PROPOSED TECHNICAL SPECIFICATION (TS) CHANGE

SEQUOYAH NUCLEAR PLANT (SQN) UNITS 1 AND 2

(TVA-SQN-TS-95-07)

"CONDITIONAL EXEMPTION TO END-OF-LIFE MODERATOR
TEMPERATURE COEFFICIENT SURVEILLANCE MEASUREMENT"

4.1.1.3 The MTC shall be determined to be within its limits during each fuel cycle as follows:

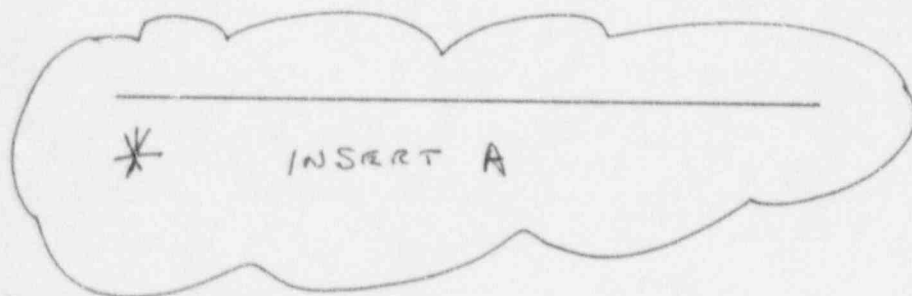
Insert A

Measurement of the MTC in accordance with 4.1.1.3.b may be suspended provided the benchmark criteria and the Revised Prediction as documented in the COLR are satisfied. Data required for the calculation of the Revised Prediction is provided in the Most Negative Temperature Coefficient Limit Report per Specification 6.9.1.15.

4.1.1.3 The MTC shall be determined to be within its limits during each fuel cycle as follows:

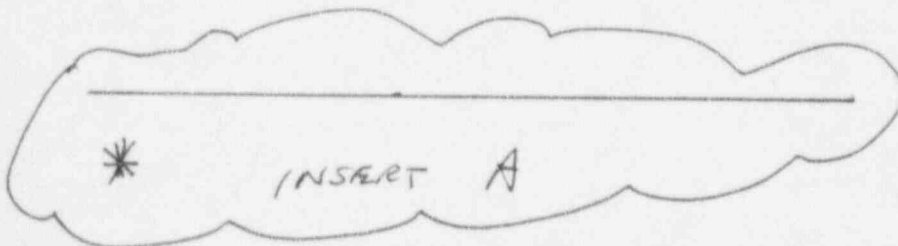
Insert A

Measurement of the MTC in accordance with 4.1.1.3.b may be suspended provided the benchmark criteria and the Revised Prediction as documented in the COLR are satisfied. Data required for the calculation of the Revised Prediction is provided in the Most Negative Temperature Coefficient Limit Report per Specification 6.9.1.15.
